December 17, 1996  
38-2659

**Subject: Facility License R-38; Docket 50-89: Request for License Amendment to Withdraw Authorization to Operate General Atomics' TRIGA Mark I Non-power Reactor**

This attachment contains the following information submitted in support of General Atomics' (GA's) request for a possession only license amendment for its non-power reactor License R-38:

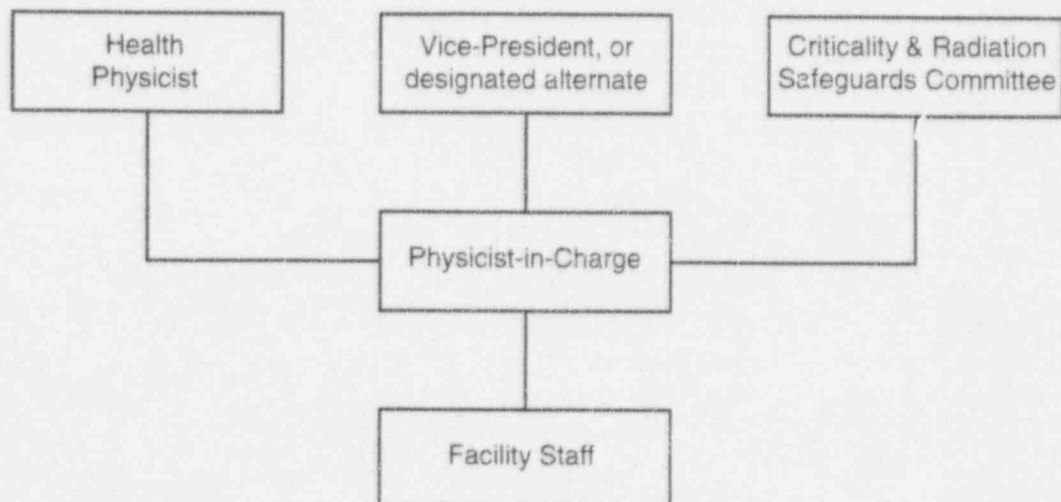
*Amend* this section to delete reference to the Physicist-in-Charge being a licensed senior operator, and to delete reference to safe operation of the reactor. The amended Section 9.1 is to read:

"The facility shall be under the supervision of the Physicist-in-Charge or his designated alternate. The minimum qualification for the Physicists-in-Charge shall include a Bachelor's degree or equivalent academic education and three years experience in activities related to reactor operations. He shall be responsible to a Vice President whose duties include responsibility for research and development, or his designated alternate, for limiting exposure of personnel and dispersal of radioactive material. The reactor shall be related to the corporate structure as shown in the following chart:"
